**From:** [Singal, Balwant](#)  
**To:** [Kee, Ernie](#)  
**Cc:** [Bailey, Stewart](#); [Smith, Stephen](#)  
**Subject:** RE: Public Meeting for ECCS Debris Screen Penetration Testing Plan  
**Date:** Thursday, August 30, 2012 3:45:00 PM  
**Attachments:** [Preliminary NRC Staff Comments.docx](#)  
[ALION-PLN-STPNOC-8511-01 \(Rev 0C\).pdf](#)

**South Texas Project (STP) CFD Data Analysis Report**  
**Document No. ALION-PLN-STPNOC-8511-01, Revision 0C**  
**(Bypass Test Protocol)**  
**U.S. Nuclear Regulatory Commission (NRC) Staff Comments**

Document No: ALION-PLN-STPNOC-8511-01	Revision: 0C	Page 1 of 26
Document Title: South Texas Project Risk Informed Strainer Penetration Test Plan		
Project No: 261-8511		
Project Name: South Texas Project GSI-191 Risk Informed Analysis		
Client: South Texas Project Nuclear Operating Company (STPNOC)		
<p>Document Purpose/Summary:</p> <p>This document presents the Alion test plan for the South Texas Project (STP) fiber only strainer penetration testing, which will utilize the Alden Research Labs (ARL) test facility.</p> <p>This report is not safety related</p>

**Figure 3.1-1 – Distribution of Possible Fiber Debris Volume at STP**

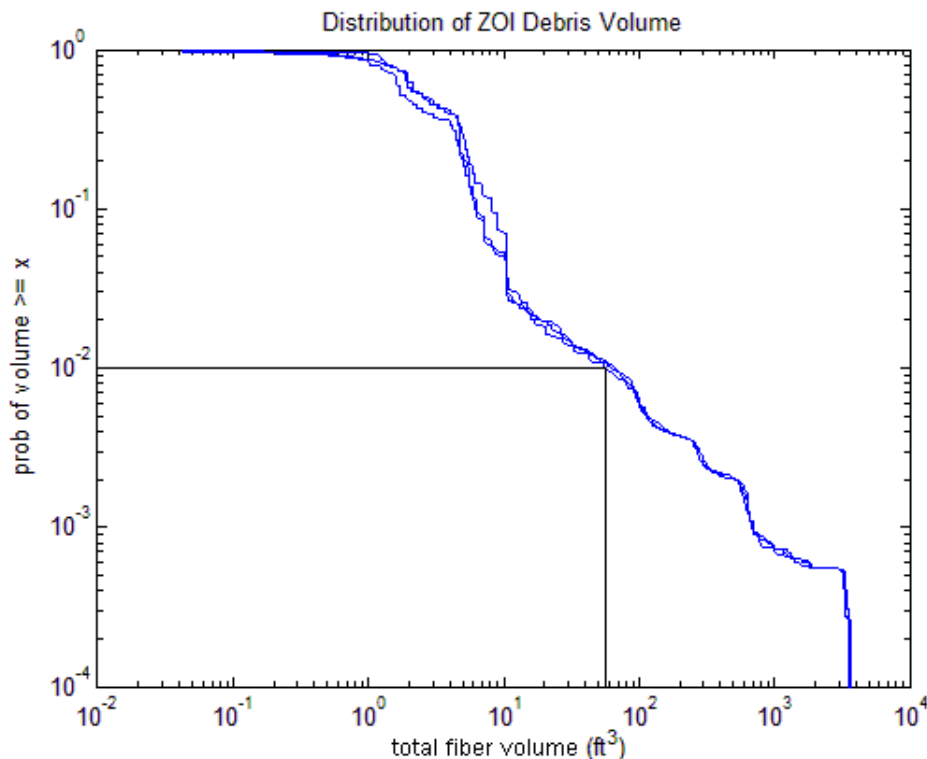
- 4) Will the fiber be heat treated as part of the preparation procedure?
- 5) The reviewer did not validate the probability of debris volume distribution provided in the protocol.

**Figure 4.6-1 – Debris Fraction Transported to Sump as a Function of Pool Turnover**

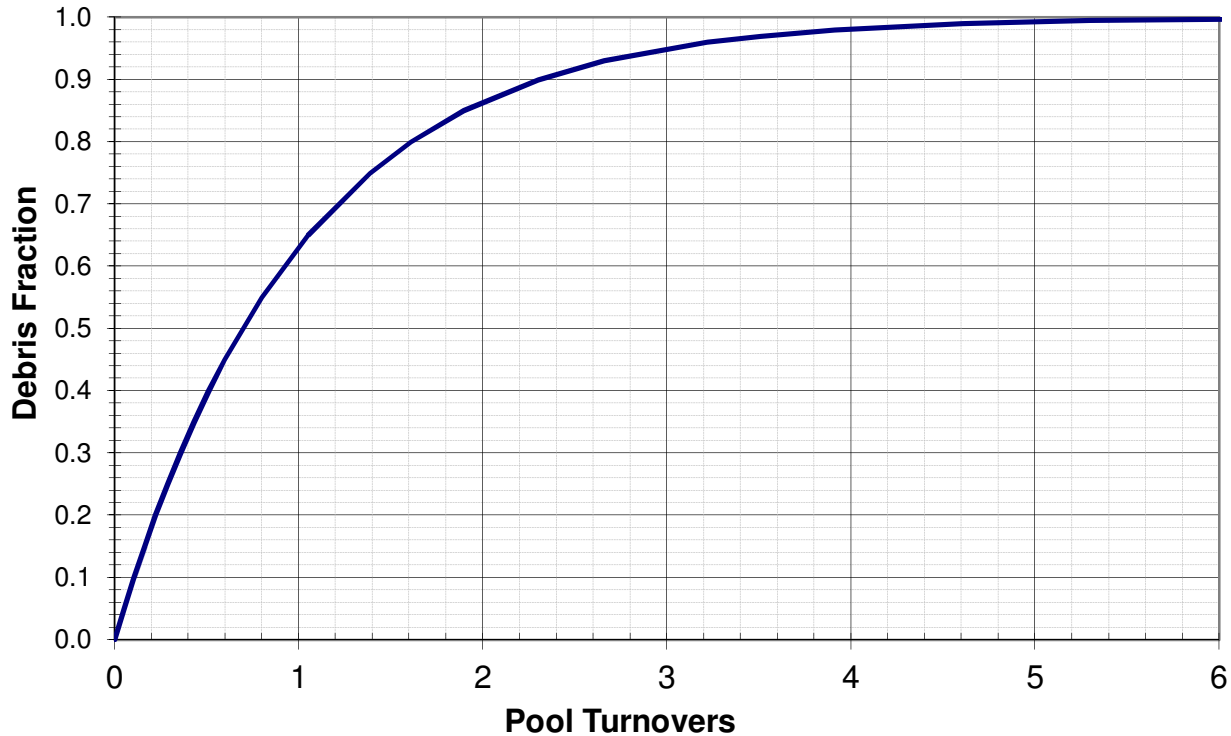
- 12) The minimum of 5 pool turnovers is adequate for systems that are well mixed. If significant amounts of fiber are floating or settled additional time may be required to ensure close to 100% filtration.
